Groundwater Transfer Review Summary Form

Transfer/PA # T- 14608

Application: T-14608

Applicant Name: T&K Sester Family, LLC

West-East Cross-Section 1**West-East Cross-Section 2**

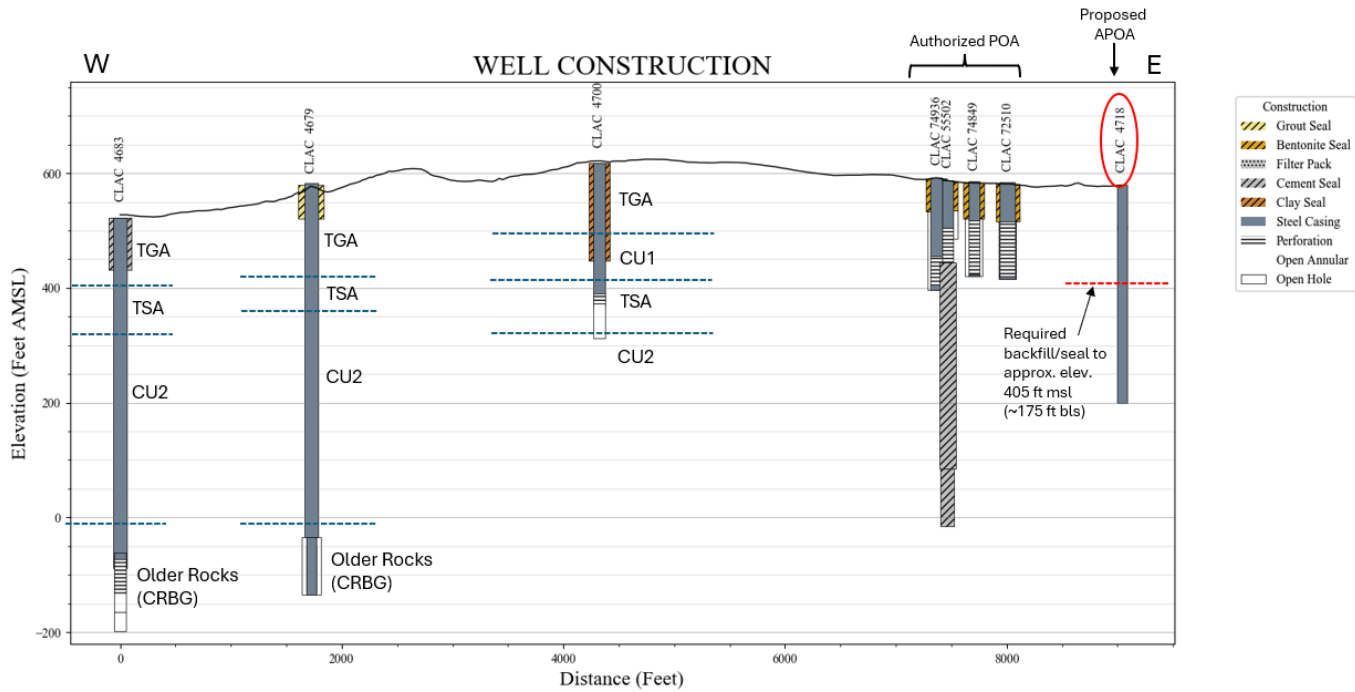
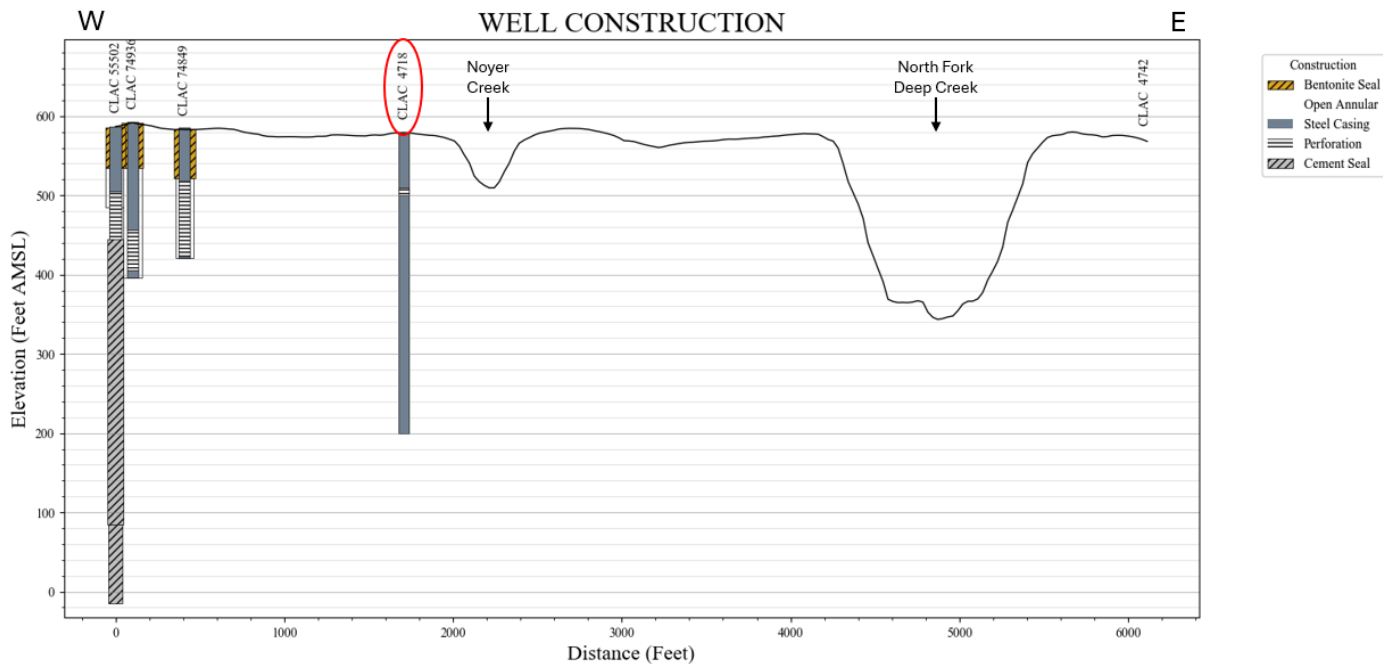
According to USGS hydrostratigraphic delineations provided for nearby wells CLAC 4683, CLAC 4679, and CLAC 4700 (Swanson and others, 1993), it appears that the authorized POA obtain groundwater from the TGA and perhaps water-bearing portions of CU1 (see attached “West-East Cross-Section 1”; it is often difficult to distinguish between water-bearing units in major confining units and vertically adjacent aquifers, particularly when limited to using only cutting descriptions provided on drilling logs).

It is notable that the backfilling/cementing of authorized POA CLAC 55502 (“Well 1”) from its original total depth of 600 feet to 140 feet effectively limited its exposure to only the TGA; prior to that alteration (documented by CLAC 55576), CLAC 55502 intersected not only the TGA, but also the underlying Troutdale Sandstone Aquifer (TSA) and water-bearing layers of Confining Unit 2 (CU2).

Based on currently-available information, it is assumed that proposed APOA CLAC 4718 obtains groundwater not only from the TGA but also from the deeper TSA and possibly also water-bearing layers within CU2.

To ensure that proposed APOA CLAC 4718 obtains groundwater only from the same authorized source (TGA) (and to maintain consistency with previous OWRD findings for related application T-13348), CLAC 4718 would have to be backfilled/sealed from its total reported depth of 380 ft up to approximately 175 ft bls (elevation ~405 ft msl) (see attached cross-section). According to the CLAC 4718 well log the 175-ft depth is the approximate mid-point of a thick clay layer that likely corresponds to CU1, separating the TGA from the underlying TSA.
